Subject: Request for Class 2 Permit Modification to the Los Alamos National Laboratory

(LANL) Hazardous Waste Facility Permit for Technical Area 54, Building 38 West,

Class 2 Permit Modification Request for
Technical Area 54, Building 38 (TA-54-38) West
Los Alamos National Laboratory Hazardous Waste Facility Permit
April 2013

Figure G.16-1: Technical Area 54, Building 38 (High, and Low Bay, and Loading Dock Sampling Locations)

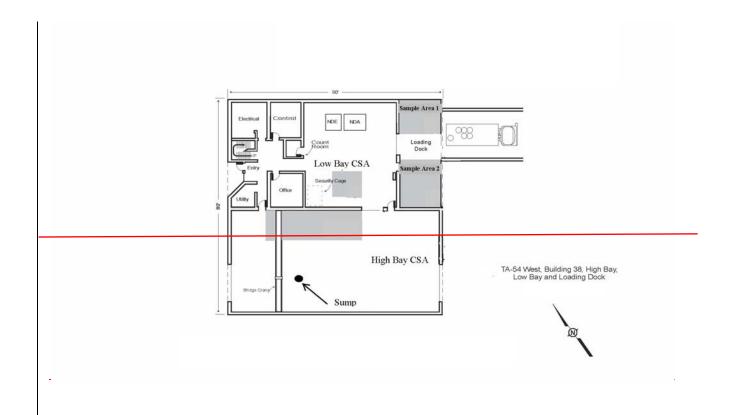
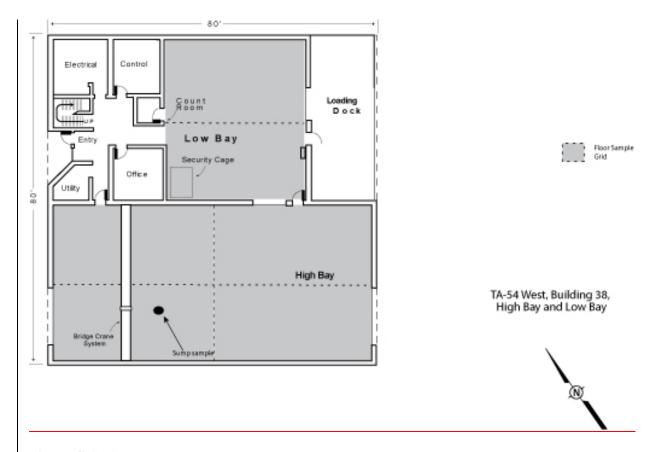
Permit Section	Revision Description	Justification
Attachment G.16,	Figure has been replaced.	Revision illustrates the larger footprint of
Figure G.16-1	I igure nus seen replaced.	the entire High Bay and Low Bay as the
118010 0.10 1		permitted unit boundary, incorporates
		sample areas for the larger footprint, and
		removes the loading dock sample locations.
		Outdated truck ramp and truck diagram
		formerly included on the figure and the title
		of the figure was revised to remove
		reference to the loading dock.
Attachment G.17,	No changes pagesary	Table of contents, list of tables, and list of
	No changes necessary.	
Table of Contents,		figures do not change as part of this permit
List of Tables, and		modification request. However, page
List of Figures		numbers may change based on approved
A.: 1 . G.17	N. I	changes.
Attachment G.17,	No change necessary.	Information in the introduction section does
Section 1.0		not change as part of this permit

- a. fournine wipe samples from the High Bay (see Figure G.16-1):
 - 1. twofour from the floor;
 - 2. one from theeach wall; and
 - 3. one from the sump;

d.2. two wipe samples from the Loading Dock areas identified as 'sample area 1' and 'sample area 2' (see Figure G.16-1).

Figure G.17-1: Technical Area 54 West Outdoor Container Storage Unit Grid Sampling and Additional Sampling Locations

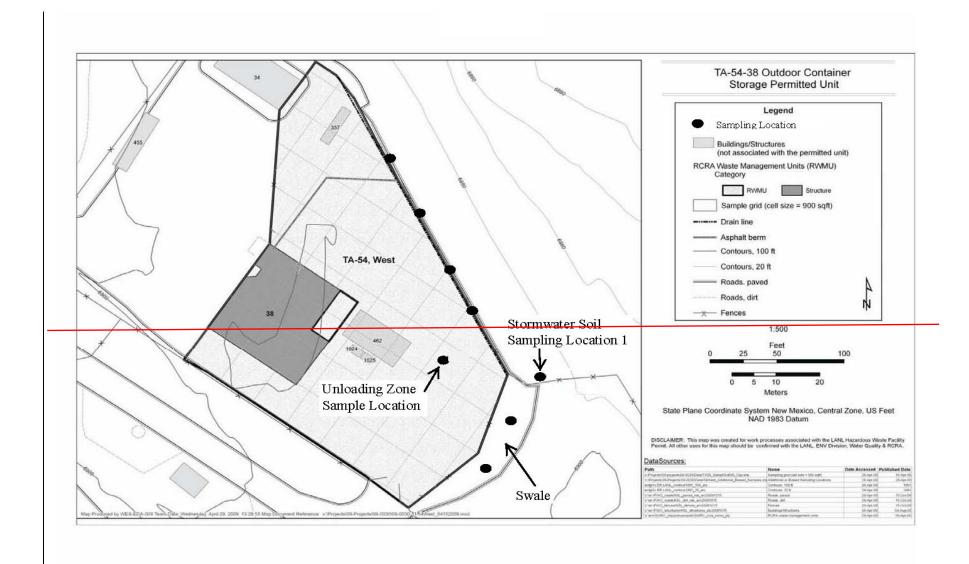
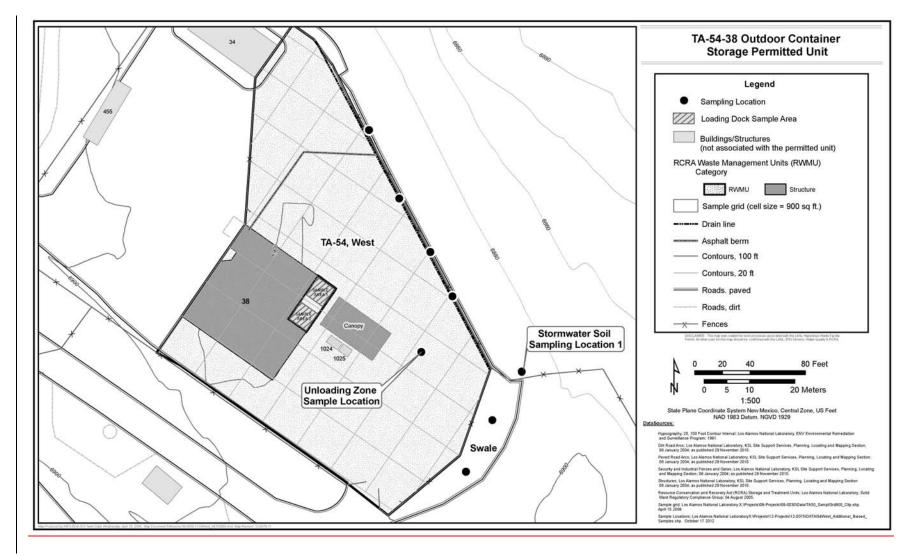
Permit Attachment G.17, Technical Area 54 West, Outdoor Container Storage Unit Closure Plan, has been revised in Sections 2.0, 3.0, 5.3.1, and 6.1; Tables G.17-1 and G.17-2; and on Figure G.17-1 to add references to a structure or correct inaccuracies. Section 2.0 of the closure plan has been revised to replace the "truck ramp" references with reference to the canopy that is located at the TA-54-38 West Outdoor Pad and took the place of the truck ramp prior to 1999. Language associated with the loading dock in the last paragraph of Section 2.0 has been revised to be consistent with the current Permit language rather than the language contained within the revised 1989 LANL Hazardous Waste Facility Permit. Section 3.0 has been revised to add a reference to the maximum quantity of hazardous waste that can be stored at the unit at any one time. Section 5.3.1 has been revised to include mention of the canopy as part of the structures that will be removed at the time of closure. Section 6.1 has been revised to include the sample locations for the loading dock that were previously included in Permit Attachment G.16. The sample areas have also been added to Figure G.17-1. The titles of Table G.17-1 and G.17-2 have been revised to correct typographical errors and an additional typographical error within Table G.17-1 has also been corrected. Additional changes to Figure G.17-1 include the removal of a structure (357) from the unit that has not been located at the unit since prior to Permit issuance and the inclusion of the canopy outside TA-54 West as a structure used for waste management at the outdoor unit. The reference to the structure number of the canopy has also been removed for consistency with other figures. Previously these structures have not been consistently updated on figures.

G.	
Attachment G.17,	No changes necessary.	No information in Tables G.16-3 through 6	
Table G.17-3		has been changed as part of this permit	
through G.17-6		modification request.	
Attachment G.17,	Figure has been replaced.	Revisions include the addition of loading	
Figure G.17-1		dock sample areas, the removal of a	
		structure (357) that does not exist at the unit.	
		The structure was removed prior to Permit	
		issuance and is not included within either	
		Figures 9 or 37 in Attachment N; however,	
		the figures for the unit were not replaced	
		consistently.	
Attachment J, TA-	Operating capacity has been	Capacity of the unit was increased to allow	
54, West Indoor	increased and total square footage	the flexibility to perform more shipments of	
	of the unit has been corrected.	waste. The total square footage of the unit	
		was also corrected to reflect the area of the	
		High Bay and the Low Bay.	
Attachment J, TA-	Operating capacity has been	Capacity of the unit was increased to allow

An additional two wipe samples are required from the Loading Dock areas identified as 'Sample Area 1' and 'Sample Area 2.' Figure G.17-1 illustrates the sampling locations discussed in this section.

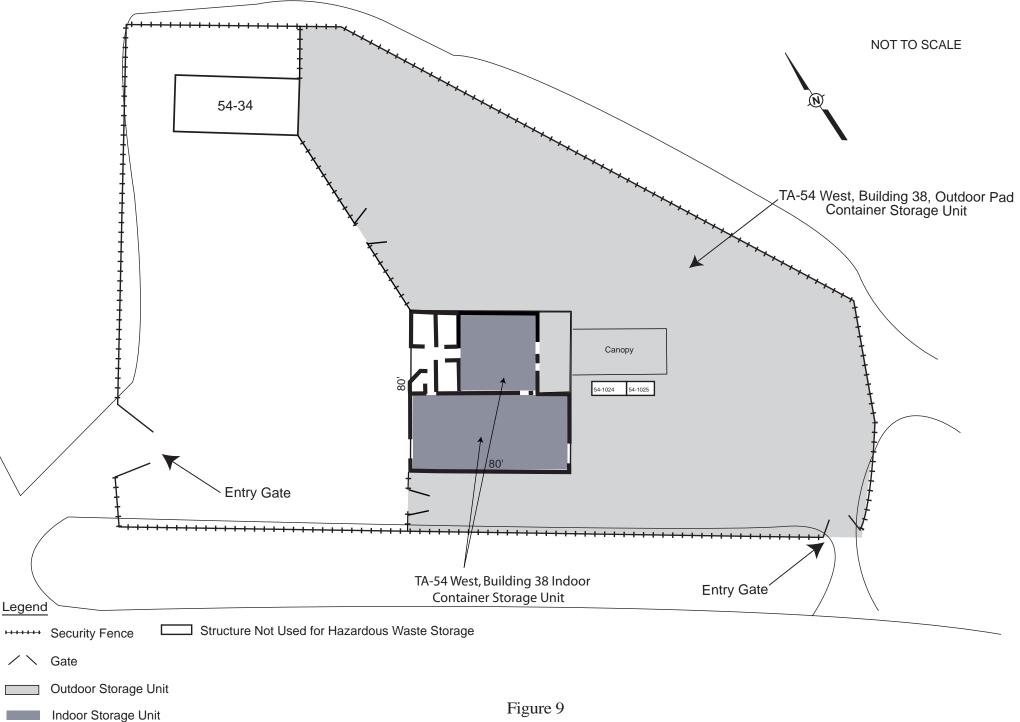
Figures 9 and 37 within Permit Attachment N, *Figures* have been updated to include the entire High Bay and Low Bay as part of the TA-54-38 West Indoor Unit, unlabeled lines across High Bay have been removed from the figures, and shading on the figures has been changed to clarify the boundaries of indoor and outdoor units.

Permit Section	Revision Description	Justification
Attachment N,	Figure has been replaced.	Change has been made to illustrate the
Figure 9		larger footprint of the entire High Bay and
		Low Bay as the permitted unit boundary.
		The color of the canopy on the figure was
		also changed to reflect that it is not used for
		hazardous waste storage to be consistent
		with the closure plan and an item was added
		to the legend to reflect these changes.
Attachment N,	Figure has been replaced.	Change has been made to illustrate the
Figure 37		larger footprint of the entire High Bay and
		Low Bay as the permitted unit boundary.
		The color of the canopy on the figure was
		also changed to reflect that it is not used for
		hazardous waste storage to be consistent
		with the closure plan and an item was added
		to the legend to reflect these changes.
